HAMBLETON FLAG REPORT MAY 17 – 2021

For consideration at Planned Meetings
the WBC / Flag Meeting 17th May 2021 and
the MSFW meeting circa 20th May and
this is our report for the Flood Forum 27th May

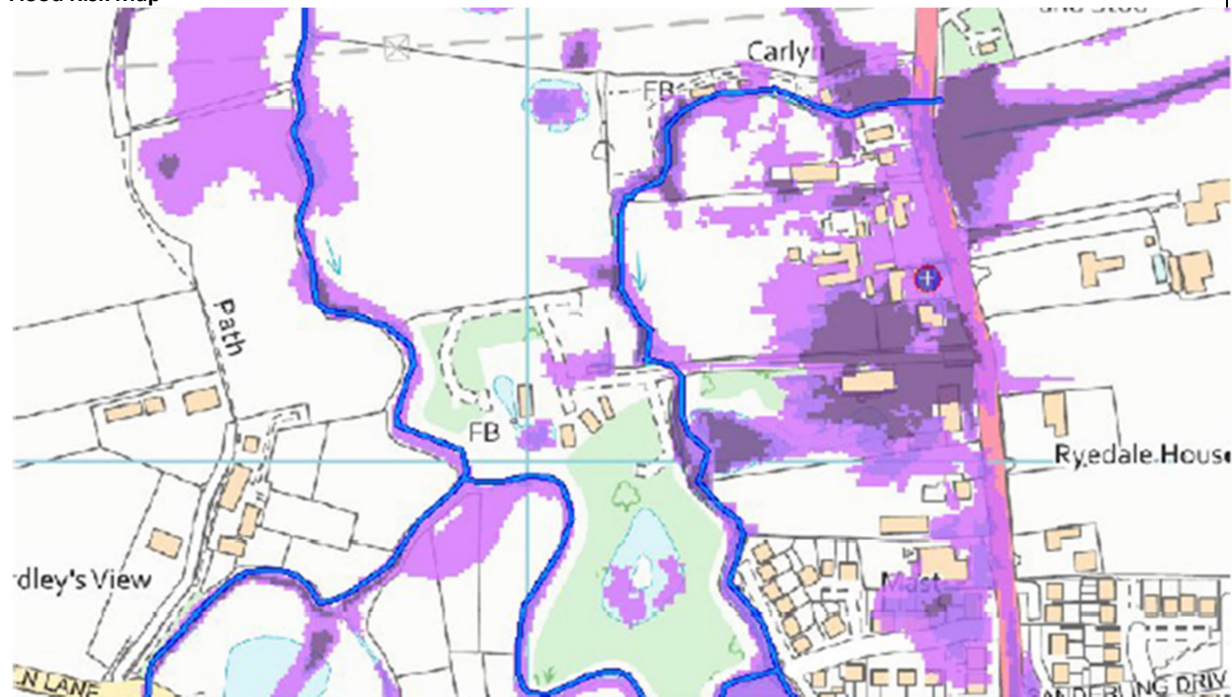
The A588 road level has risen with various constructions and resurfacing reducing kerb heights.
Can LCC respond to suggestions that have been made with regards drainage kerbs (beany blocks) on the West side of the A588 in front of the vulnerable properties (ref D) preventing /reducing ingress into the properties? Of course the successful operation of this would require the 'Queensland' Culvert (ref E) to be flowing sufficiently.
Can WBC, LCC introduce/ install speed control measures so as to prevent 'waves' of water being created by inconsiderate motorists. These could be permanent that could be switched on or warning signs that be left with residents with permission to deploy. The flooding is greatly exacerbated by these bows waves of water created by the traffic.

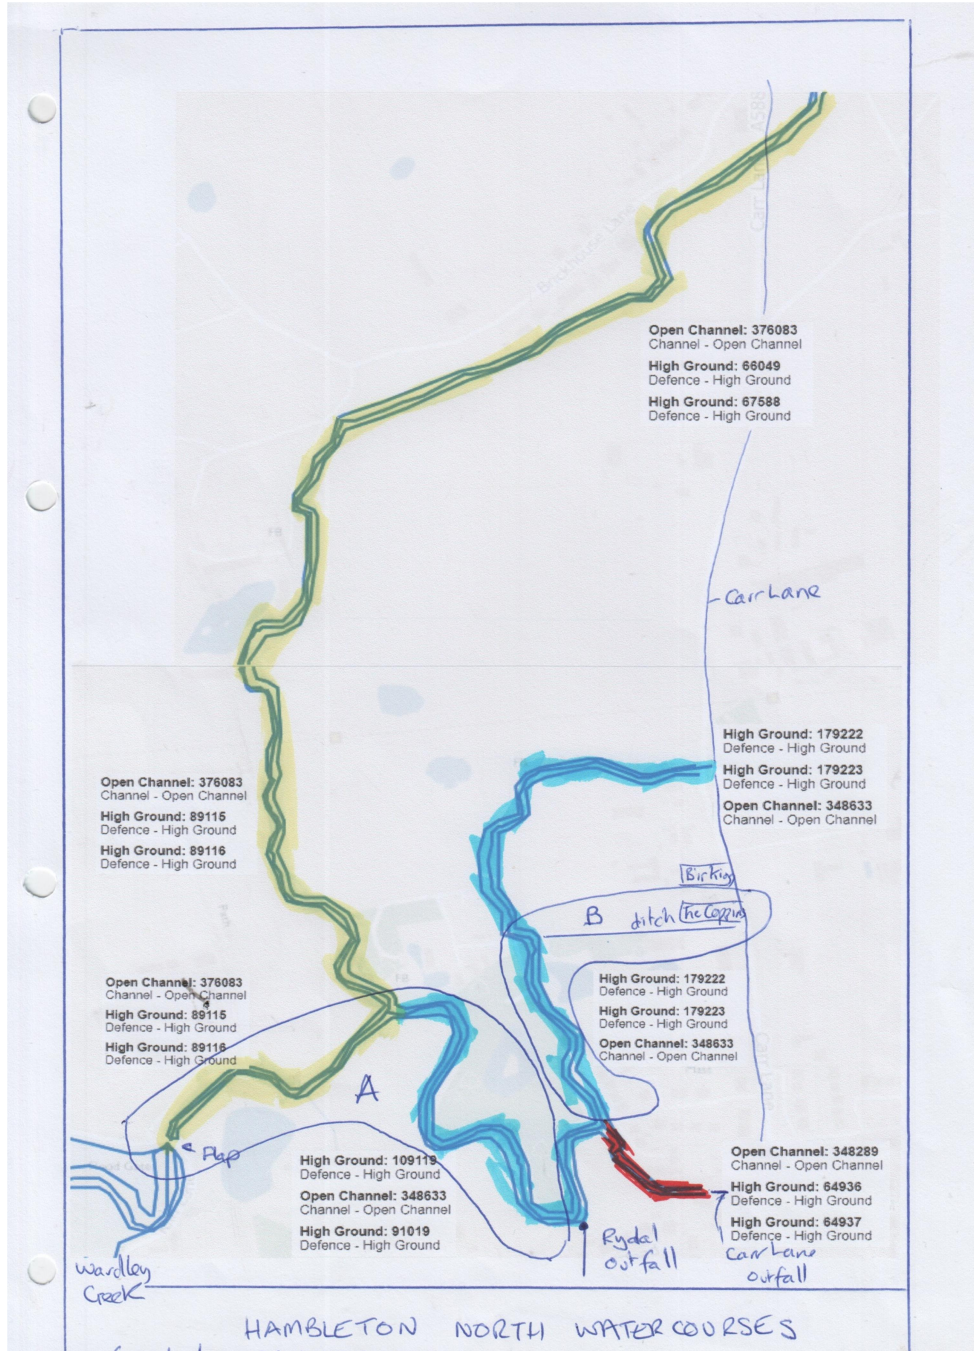
Ref F1-F2-F3-F4-F5-F6-F7-F8-F9-F10 are manholes along Kiln Lane, all of which undergo surcharge during flooding events (together with the Surface Water Gullies) and between Ref F7 and Ref F8 air bubbles are seen rising from the road surface above the sewer line.

Following prompting to Ben Wallace UU Katy Duffy met Mike O'Flaherty early 2020, UU advised that their computer modelling indicated that flooding should not occur during high rainfall events and advised that they would be installing monitors mid 2020 to gather data in order to receive this and perhaps discover where the system may be compromised. This promise was not met, it now seems that we MIGHT receive some monitoring as part of a larger scheme re 'Fleetwood' monitoring.

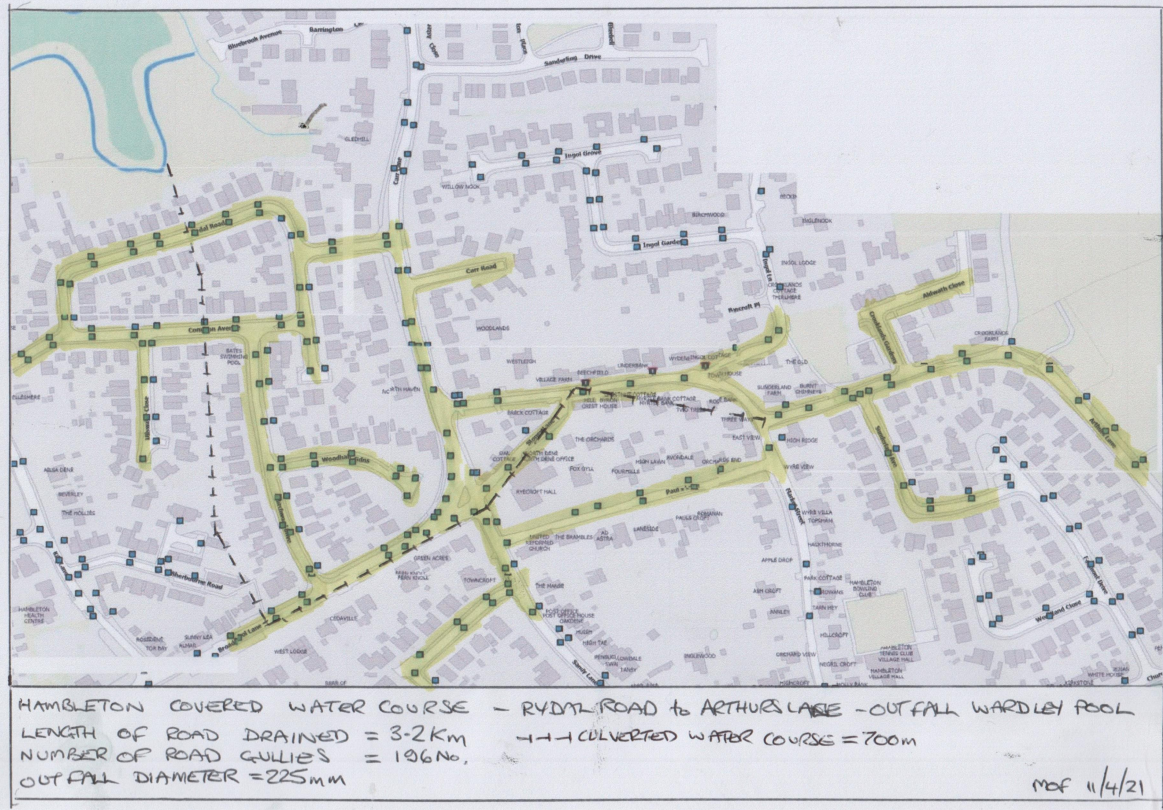
In recent meetings EA has undertaken to review the possibility of increasing the flap valve pipes so to facilitate a longer period of drainage, where level remain high behind. At the the moment a very small tide rise closes the flap
Can EA advise the current status.

AREA PLAN

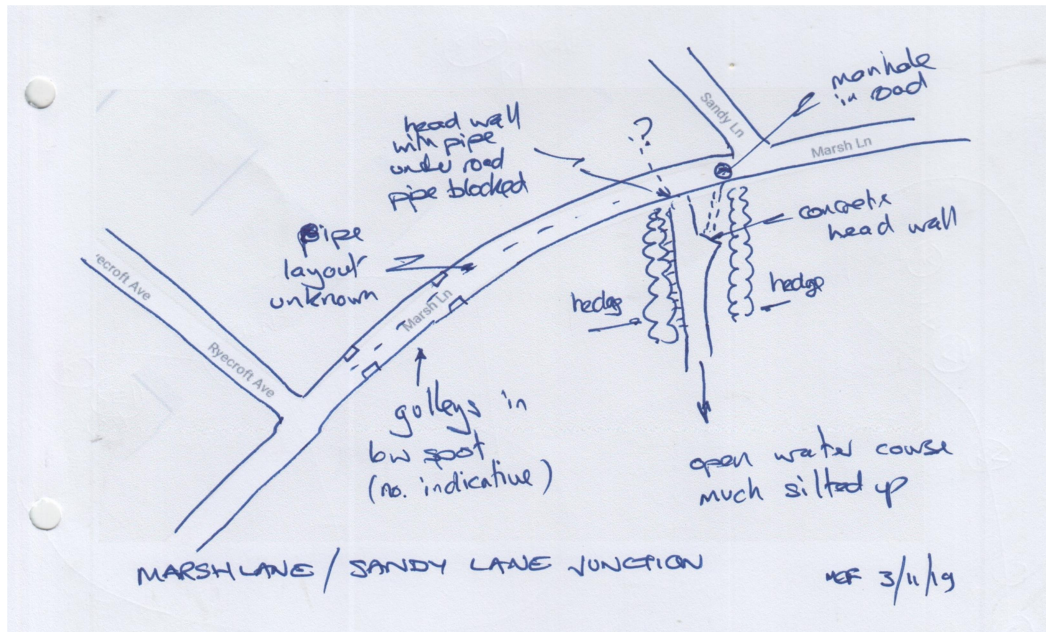
The Marsh Lane system drains nearly 500m of road with approx. 33 gullies, there are two outfalls into the open ditch. The outfalls are 50% silted. During heavy rain the roadway floods.

- 1-We request survey of the gullies and pipe system to identify action/remedial work requirement
- 2-We request EA survey and desilting of the open ditch through to Pegs Pool
